Title & Document Type: 8620A Sweep Oscillator Service Note

Manual Part Number: 8620A-6B

HP MODEL 8620A SWEEP OSCILLATOR Serial Prefix 1332A and Below

MODIFICATION REQUIRED FOR COMPATIBILITY WITH 86290A, 2.0-18.0 GHz RF PLUG-IN OR 8410B NETWORK ANALYZER

Figure 1. Blanking Switch Wiring Diagram Before And After Modification

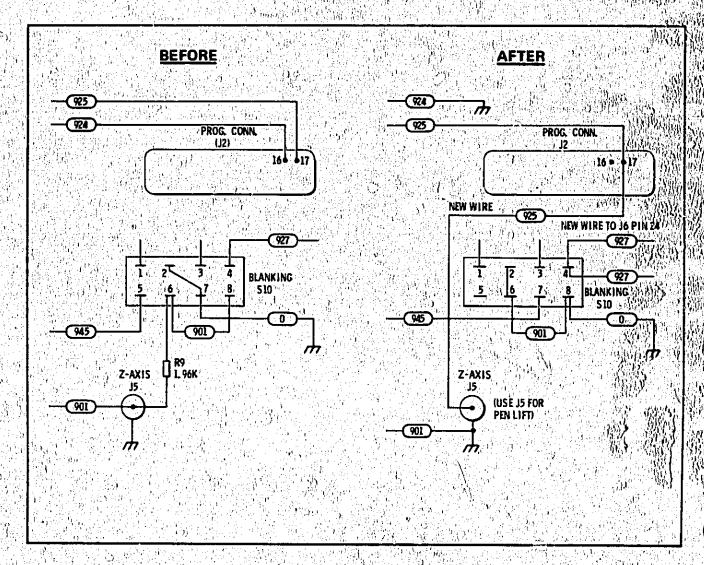
- 1. Disconnect 8620A from the power line
- 2. Remove top cover.
- 3. Cut the white/red/yellow (924) wire from the Programming Connector J2 Pin 16. Refer to Figure 1.
- 4: Connect the (924) wire just cut to the ground at Pin 6 of S10.

- 5. Remove the white/black/brown (901) wire and R9 1960 ohm resistor from the center conductor of the Z Axis output connector J5.
- 6. Connect the (901) just removed to the ground, Pin 6 of S10.

- 7. Modify the wiring to the Blanking Switch S10 on the rear panel as follows: (S10 is the three position slide switch located nearest the fan.) Refer to Figure 1 for S10 Pin location.

- A Move the white/yellow/green (945) wire from Pin 5 to Pin 7.
 - B. Move the black (0) wire from Pin 2 to Pin 8.
 - C. Remove R9, the 1960 ohm resistor, from Pin 6.

- D. Install a short bare wire jumper from Pin 2 to Pin 6. The end of the resistor just removed can be used.
- 8. Connect one end of the white/red/green (925) wire from the Modification Kit to the programming connector J2, Pin 17.

Figure 3. A7 Operations Control Board Assembly Component Locations

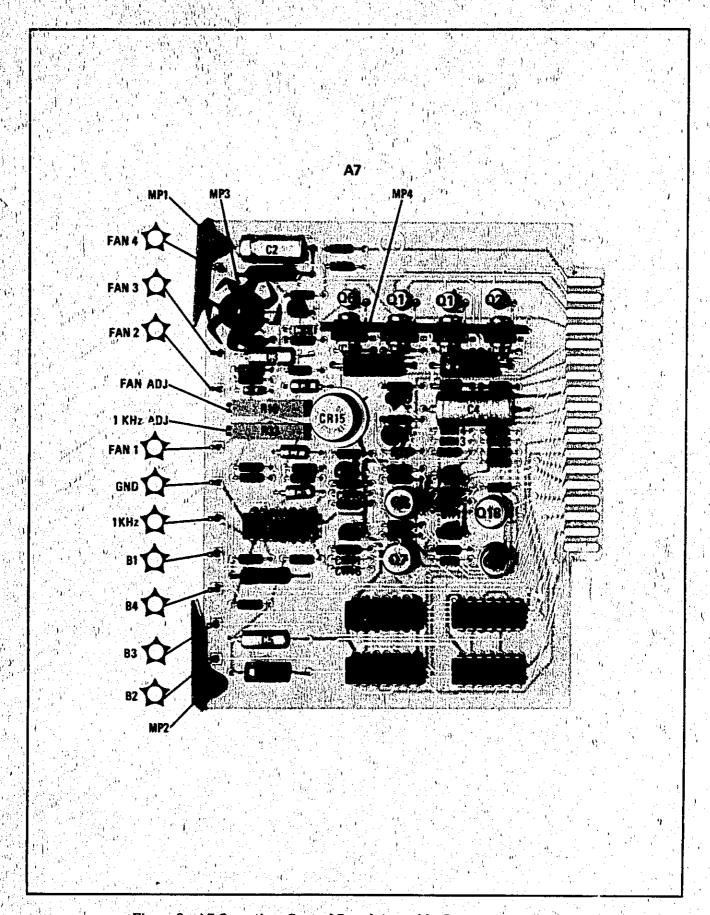
- 1. Disconnect 8620A from the power line.
- 2. Remove the bottom cover.
- 3. Install one of the brown wires from the Modification Kit between XA1, Pin 9 and XA7, Pin P. (See Figure 2 for proper mounting.)
- 4. Install the second brown wire between XA1
 Pin M and XA7 Pin 7.
- Replace the bottom cover.
- 6. Remove the top cover.
- 7. Remove the A7 Operations Control Board
 Assembly.
- 8. Remove the following components from the A7 board Q7, R20 and R21. See Figure 3 for component location.
- 9. Do Modification III.

Figure 4. A1 Sweep Generator Assembly, Jumper Position

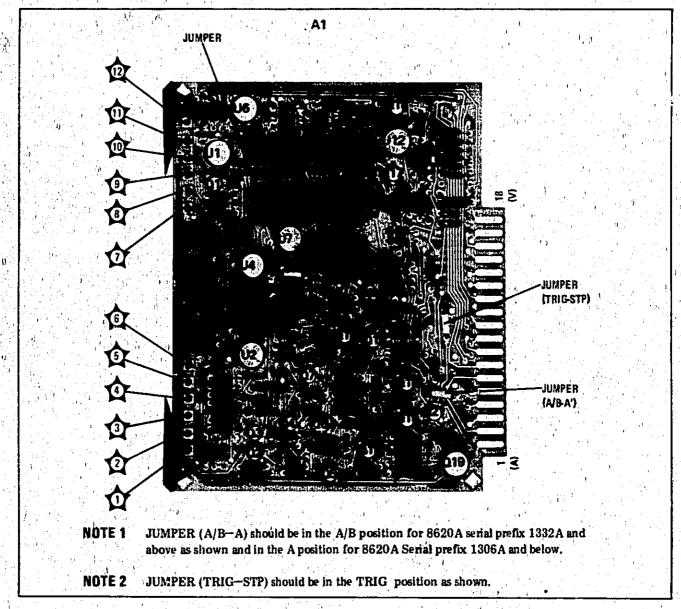
- 1. Disconnect 8620A from the power line.
- 2. Remove top cover and bottom cover.
- 3. Remove and discard the A1 Sweep Board.
- 4. Before installing the A1 Sweep Board from the Modification Kit, insure that the jumper wires are in the correct position for the particular mainframe being modified. See Figure 4 (Figure 4, A1 Board photo showing jumper placement).

Figure 5-2. Location of Adjustments

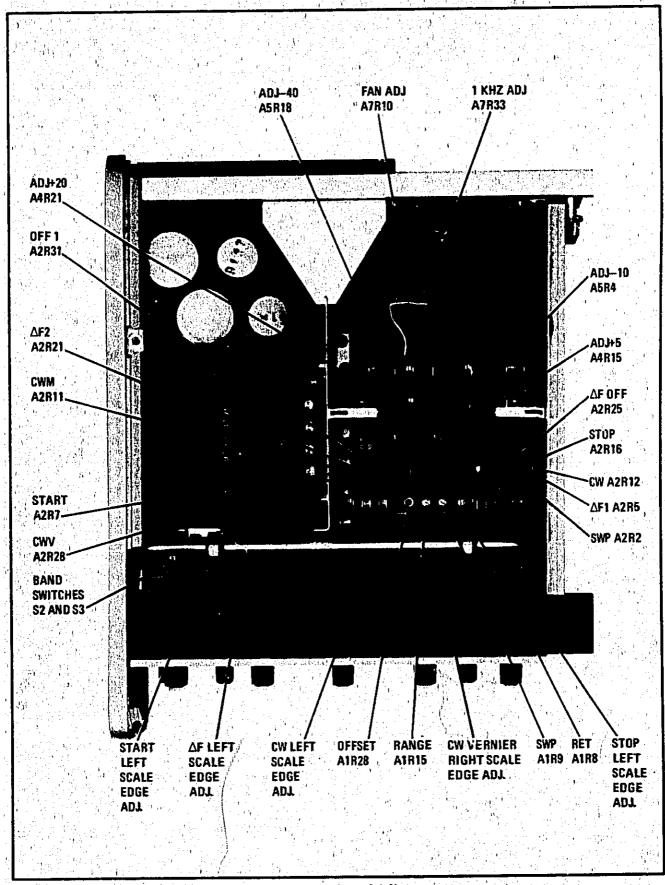
Page 5-4, Figure 5-2:

Replace Figure 5-2 with Figure 5-2 in this SERVICE NOTE.

Figure 5-3. Location of Test Points

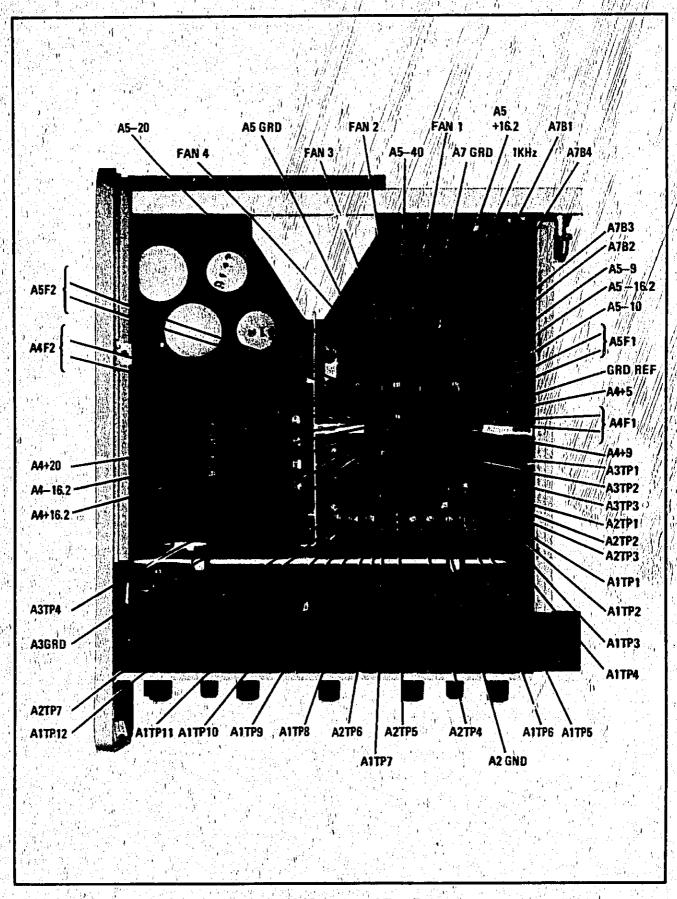
Page 5-5, Figure 5-3:

Replace Figure 5-3 with Figure 5-3 in this SERVICE NOTE.

Figure 8-8. Troubleshooting Block Diagram (1 of 3)

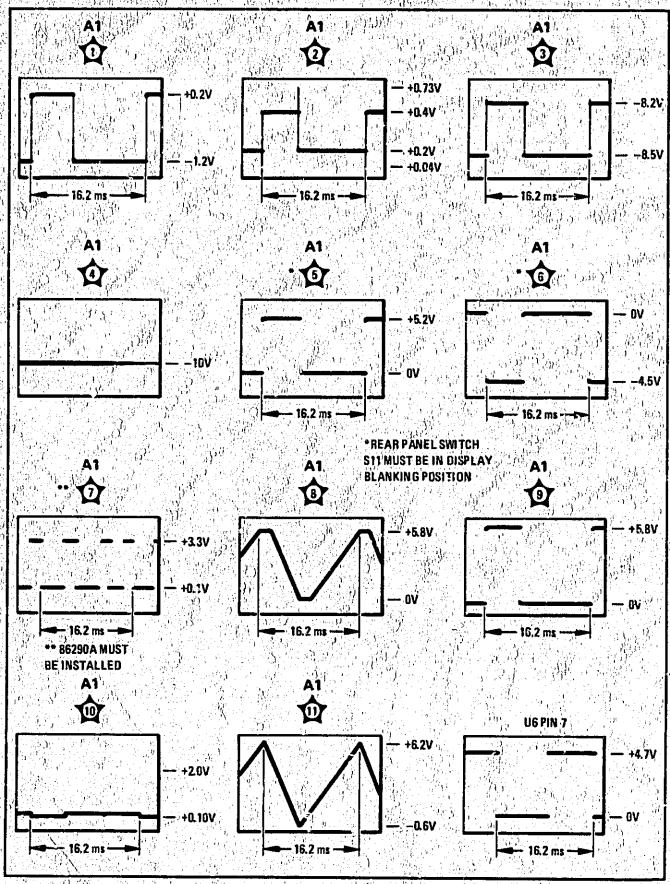
Page 8-11, Figure 8-8:

Replace Figure 8-8 (1 of 3) with Figure 8-8 (1 of 3) in this SERVICE NOTE.

Figure 8-16. A1 Sweep Generator Assembly, Component Locations

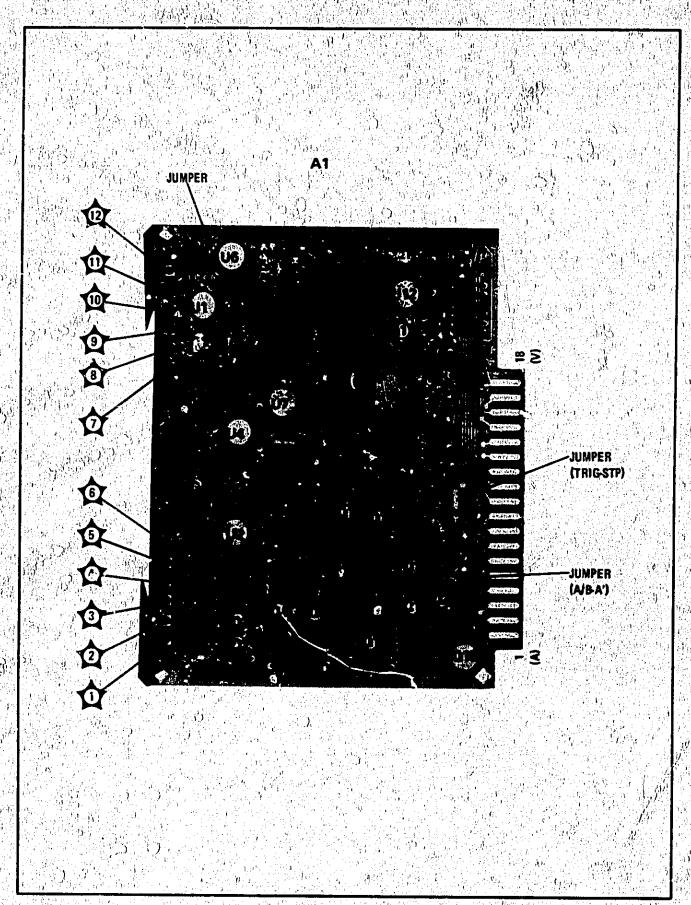
Page 8-21, Figure 8-16:

Replace Figure 8-16 with Figure 8-16 in this SERVICE NOTE.

Figure 8-17. A1 Sweep Generator Assembly, Schematic (2 of 2)

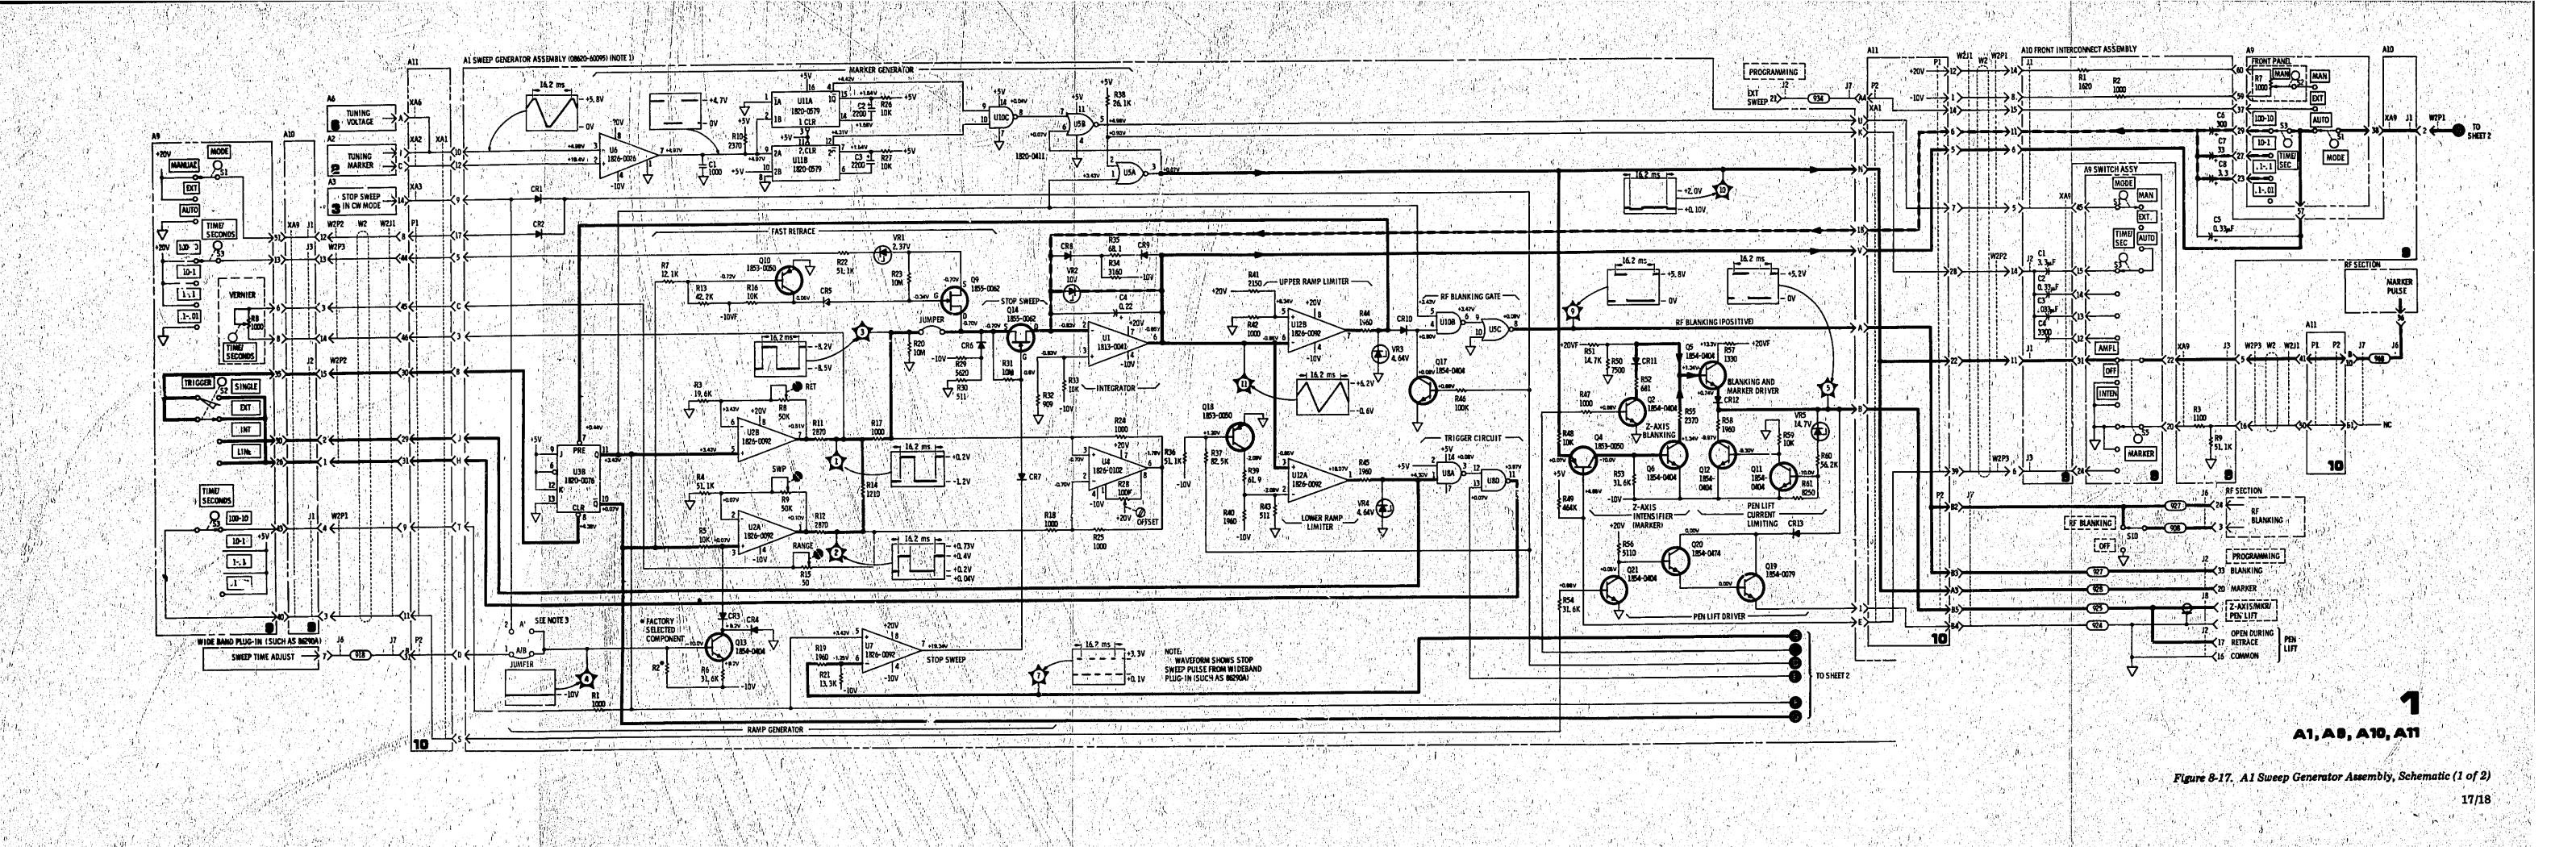
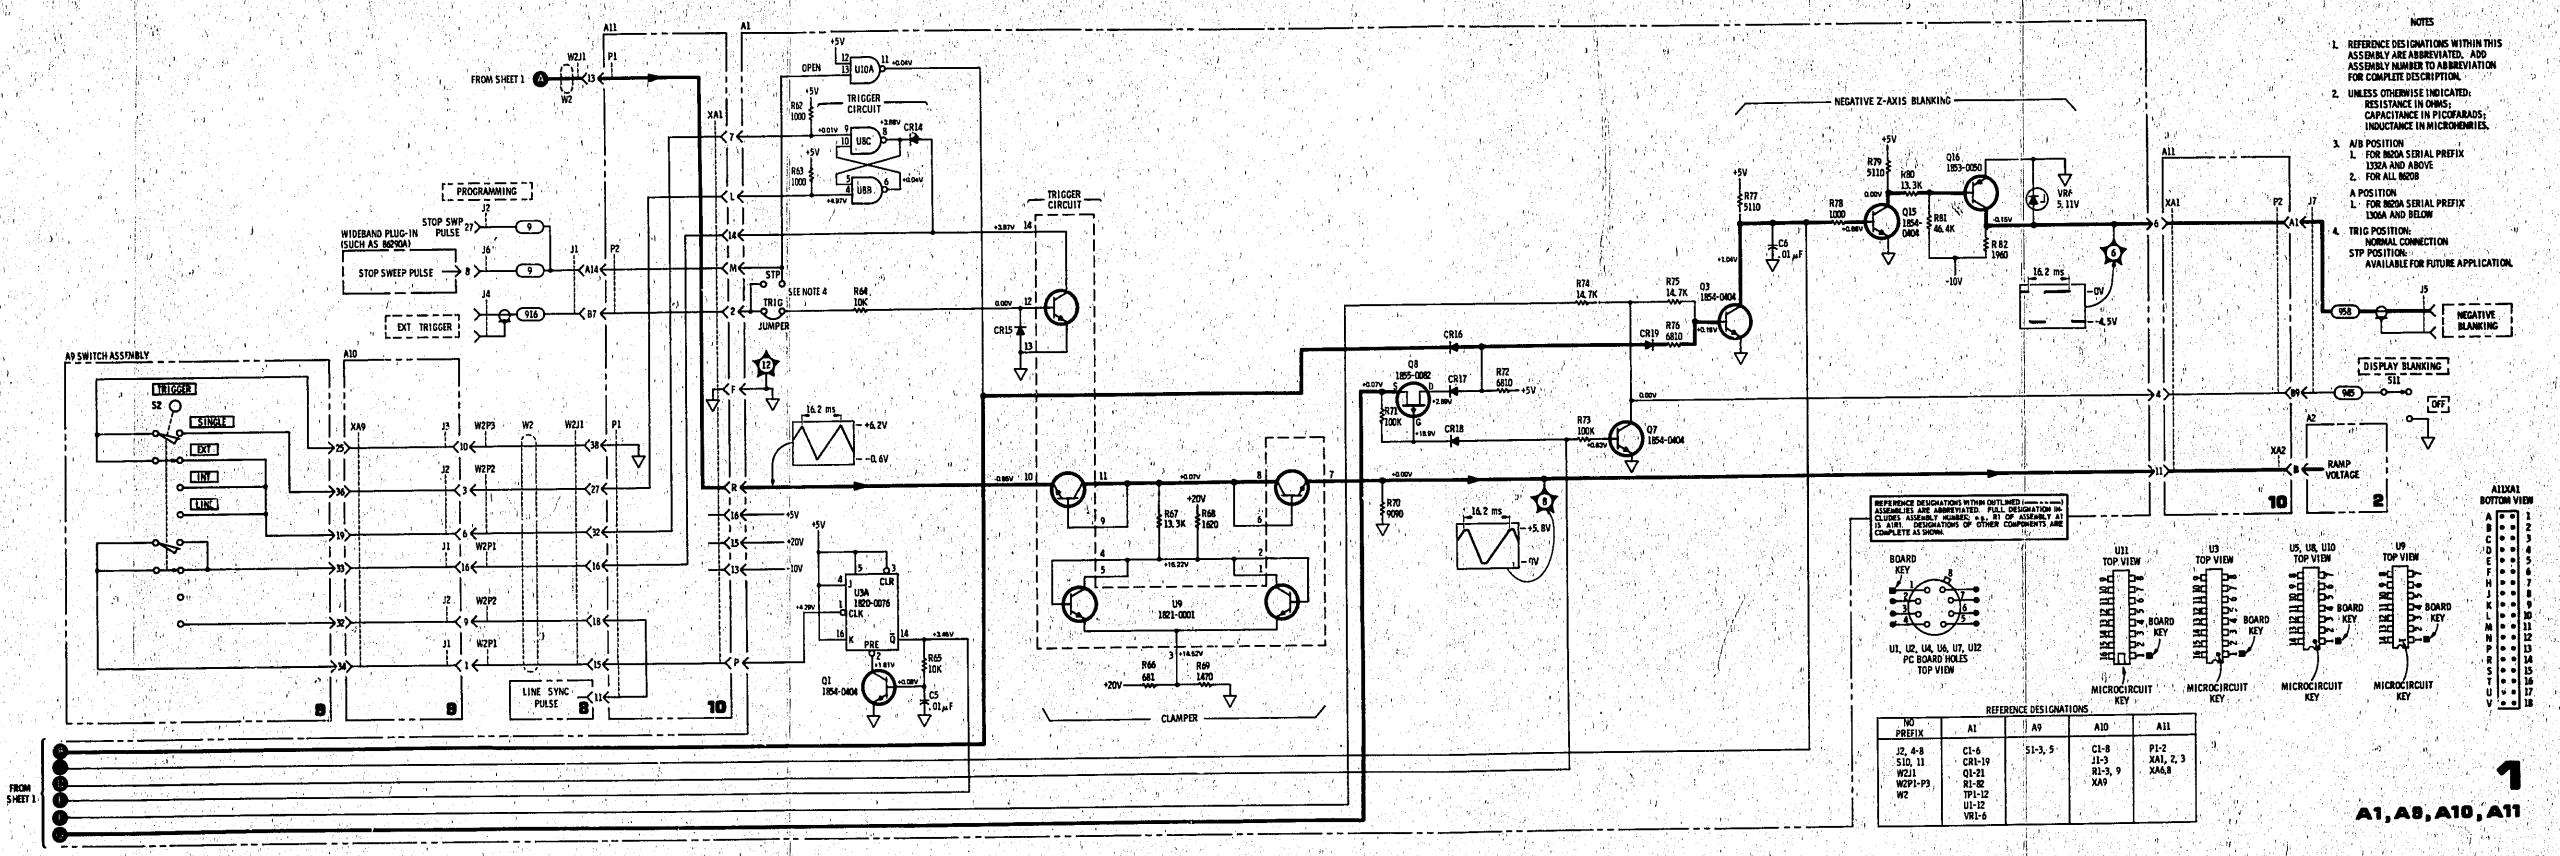
Page 8-21, Figure 8-17:

Replace Figure 8-17 with Figure 8-17 (1 of 2) in this SERVICE NOTE.

Page 8-23, Figure 8-17;

Replace Figure 8-17 with Figure 8-17 (2 of 2) in this SERVICE NOTE.

Figure 8-39. Location of Adjustments

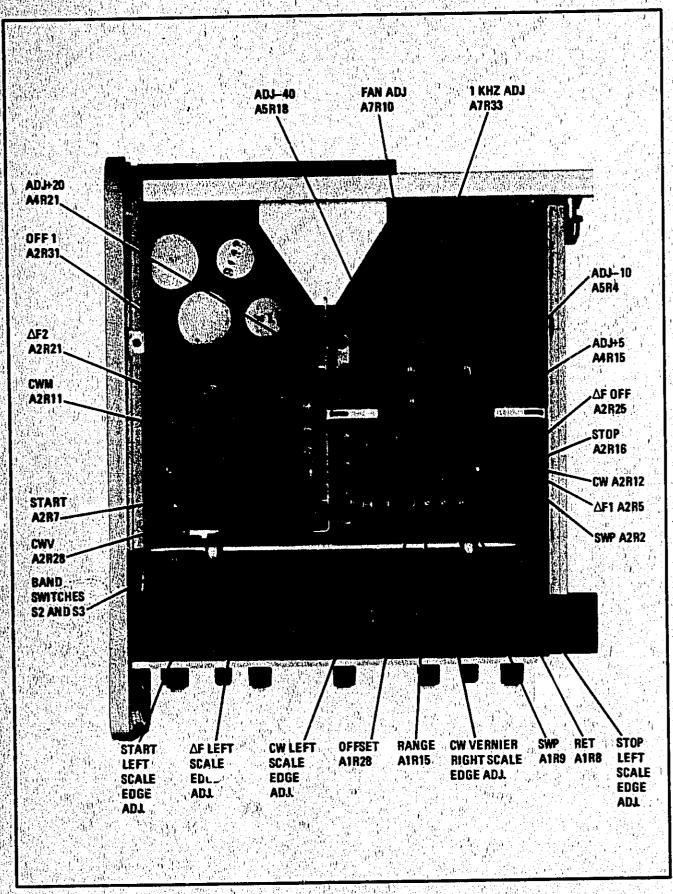
Page 8-45, Figure 8-39:

Replace Figure 8-39 with Figure 8-39 in this SERVICE NOTE.

Figure 8-40. Top View, Major Assembly and Component Locations

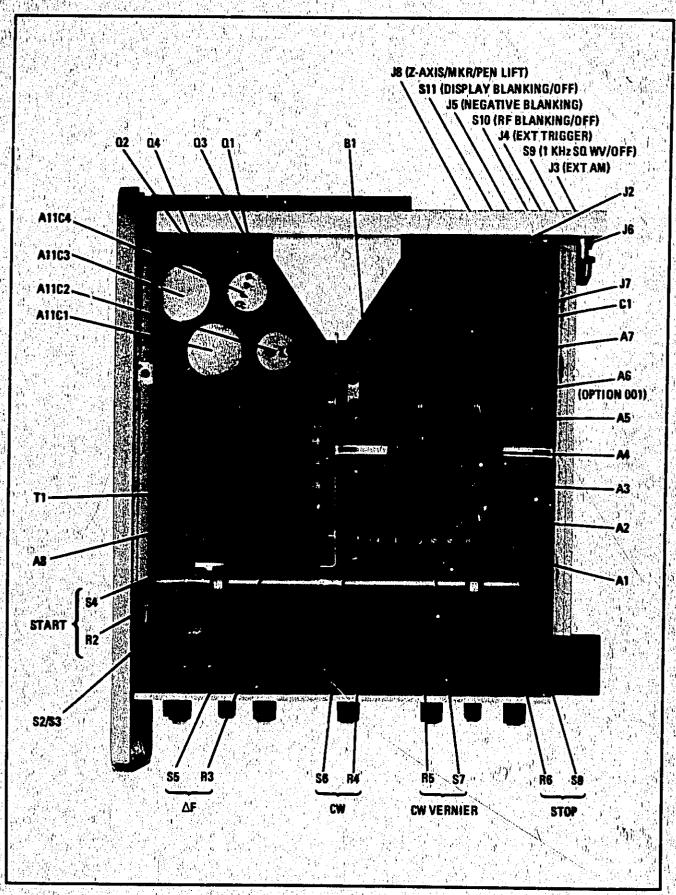
Page 8-45, Figure 8-40:

Replace Figure 8-40 with Figure 8-40 in this SERVICE NOTE.
